LOCATION
Manor Farm
Graveley

PROJECT NUMBER
BH23023

Manor Farm, Graveley

This 'Design and Heritage' statement has been prepared by Benchmark Architects in support of a planning application for Grade II Listed home Manor Farm, Graveley formerly known as Chesfield Manor.

Outbuildings - Elevations

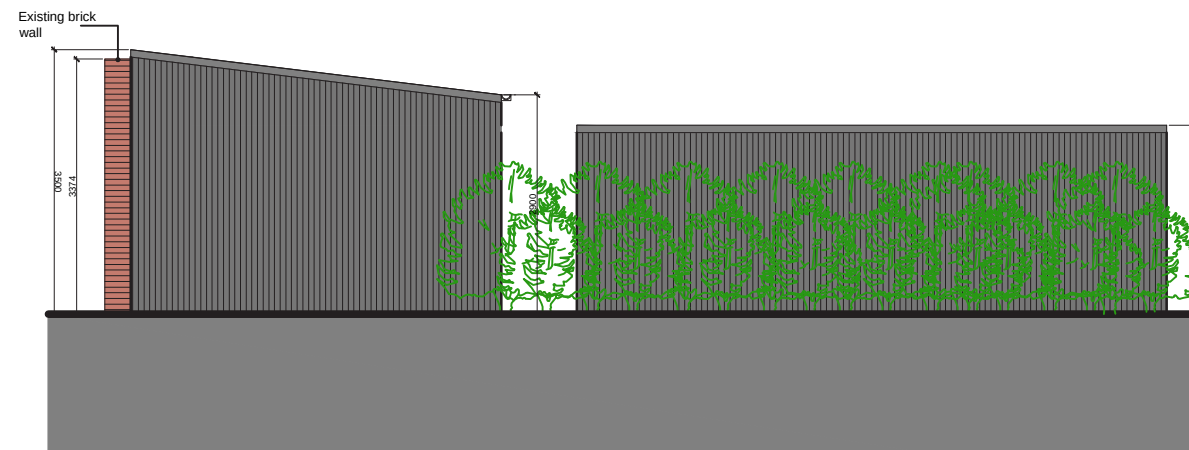
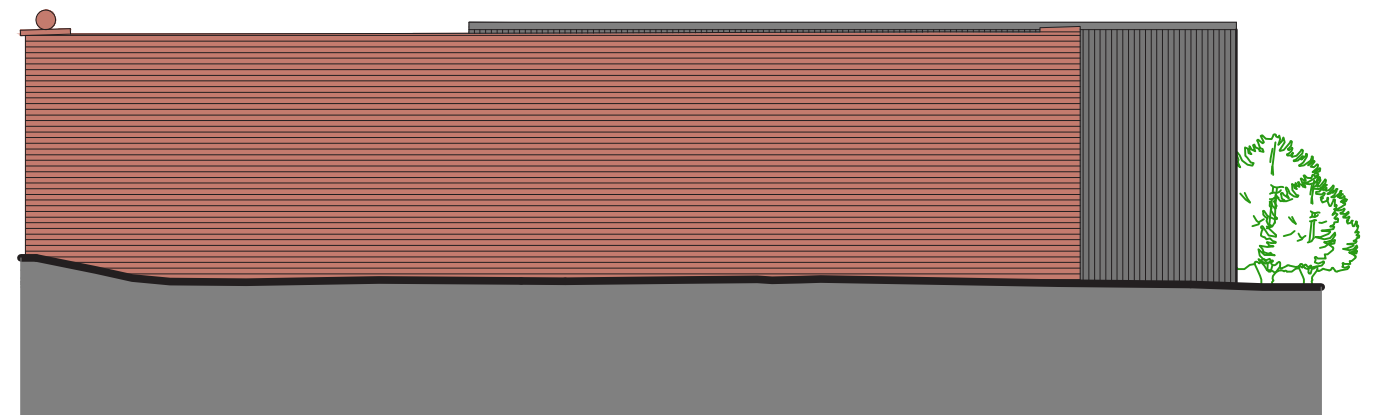
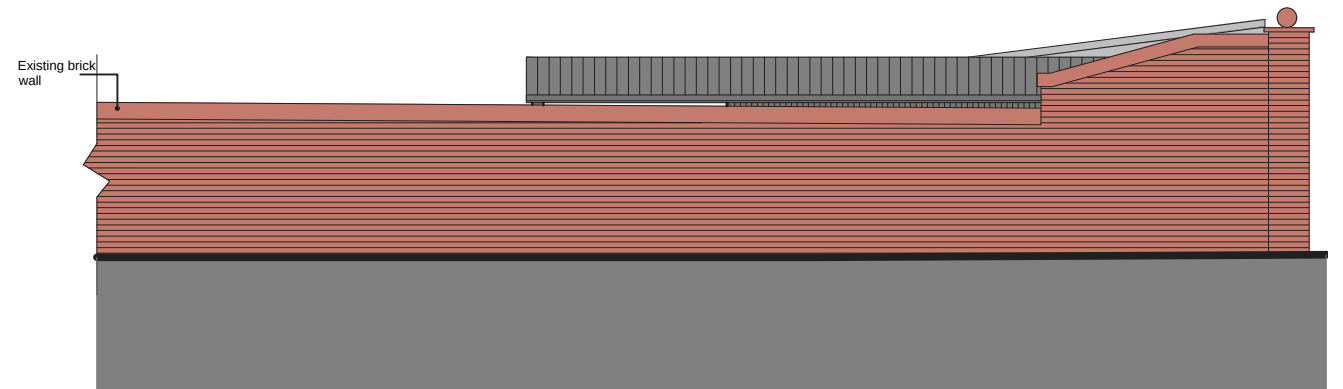
5. On a further point, the new build is that much deeper when compared with existing in which case I envisaged one of the three things happening.
 - Option 1 - Raising the height of the listed wall to screen the mono-pitched roof (not to be encouraged but I acknowledge that this wall was repaired previously).
 - Option 2 - Introducing an over sailing roof feature similar to an approved scheme that the architect is aware of elsewhere. This would be visible from outside of the site and I am reluctant to support this approach.
 - Option 3 - Maintaining the height of the wall but perhaps setting the eaves lower down which may require the internal and/or external ground level to be lowered.

The design proposal maintains the height of the existing brick wall. However the lowest existing level of (139.61m above datum level) is maintained through the entire ground floor of the outbuildings. In doing so the roof of the outbuildings does not project above the highest level of the existing brick wall significantly. A comparison of the heights of existing brick garden wall and the roof of the proposed outbuildings is shown in the elevations on the following pages.

Gate to driveway

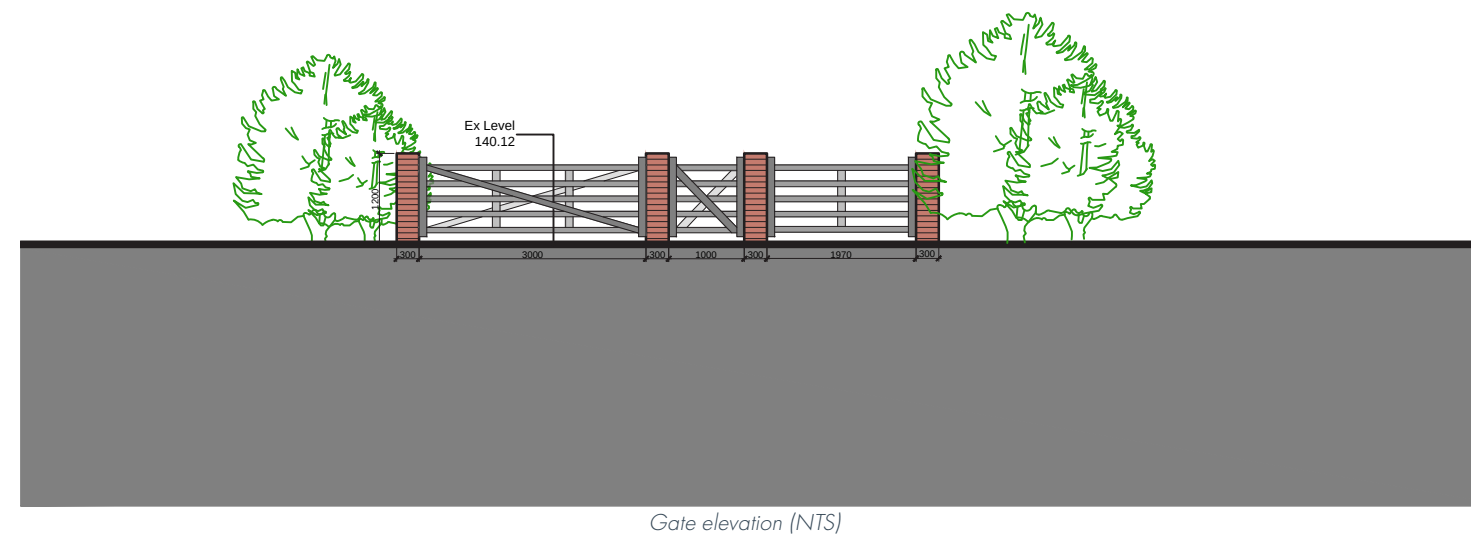
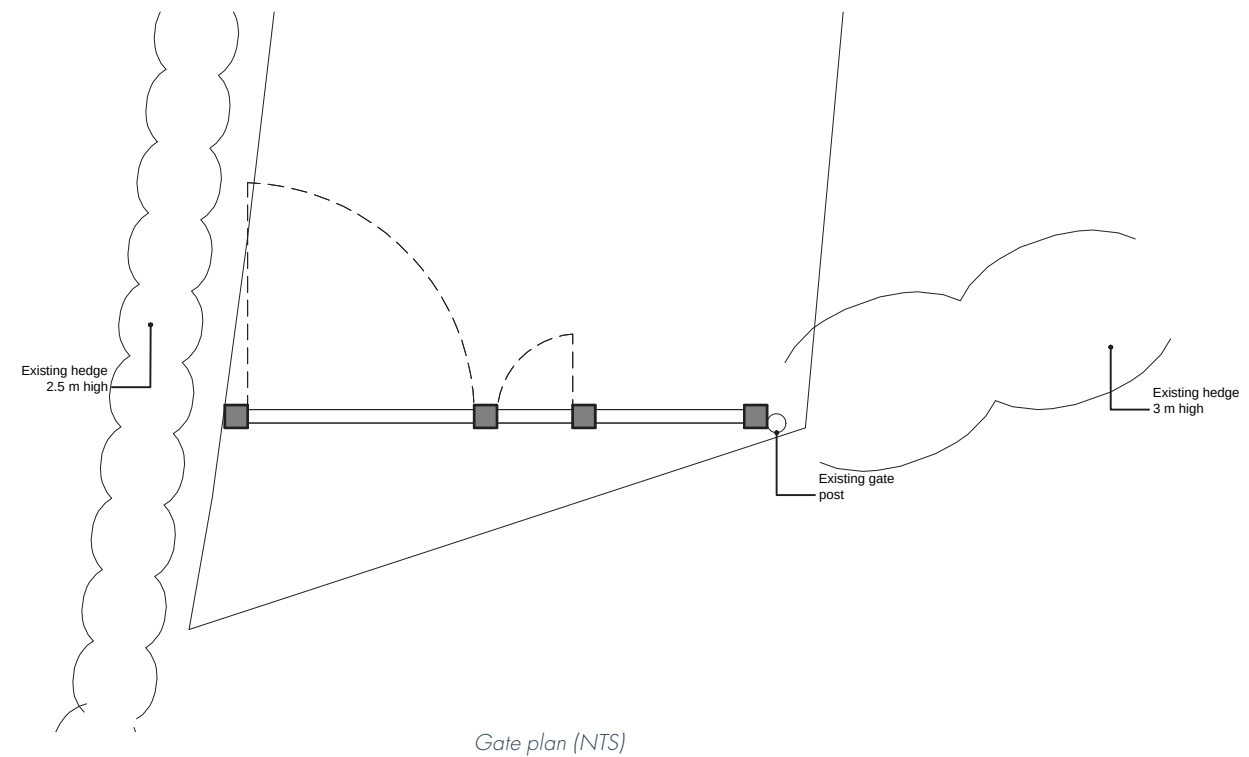
1. Unobjectionable but requiring planning permission.
The design proposal includes a gate to the driveway. Please see the following pages for the plan and elevation of the gate.

The adjacent drawings show the proposed design for the gate to the drive way. The gate will be a simple farm gate design with brick post at the ends and in between.
